PROJECT NAME: SQ ALEXANDRA PARK - BLOCK11
DRAWING TITLE: PLAN DETAILS
ARCHITECT: TEEPLE ARCHITECTS
CONTRACTOR: TRIDEL
SCALE: 1:4
DRAWN BY: S.C.
DATE: MARCH 4, 2015

DRAWING No.: P7

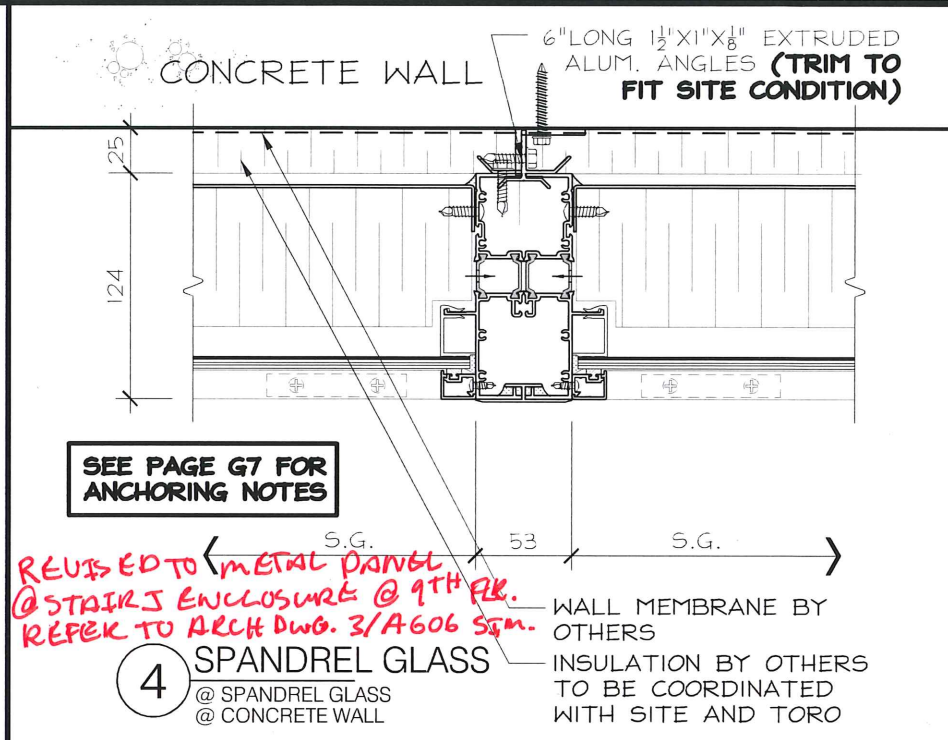
replaced w/ EIFS

4 SPANDREL GLASS
@ SPANDREL GLASS
@ CONCRETE WALL

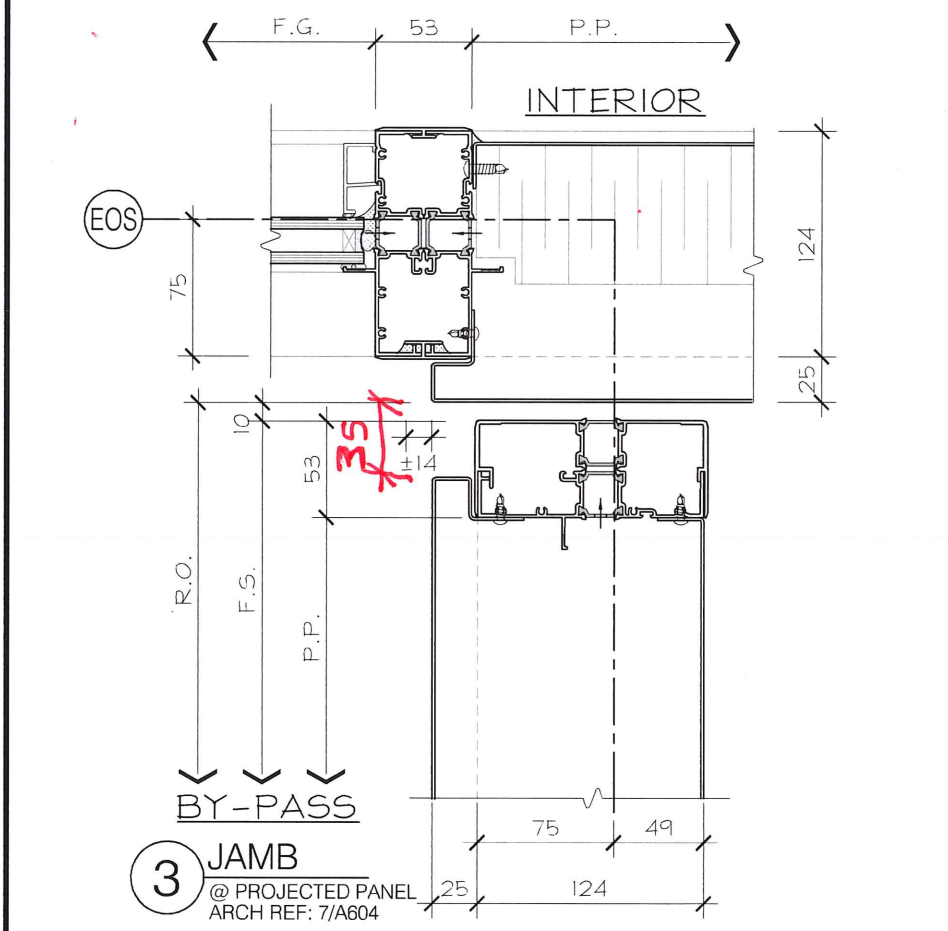
REVISED TO METAL PANEL @ STAIRS ENCLOSURE @ 9TH FL. REFER TO ARCH DWG. 3/A606 S.M.
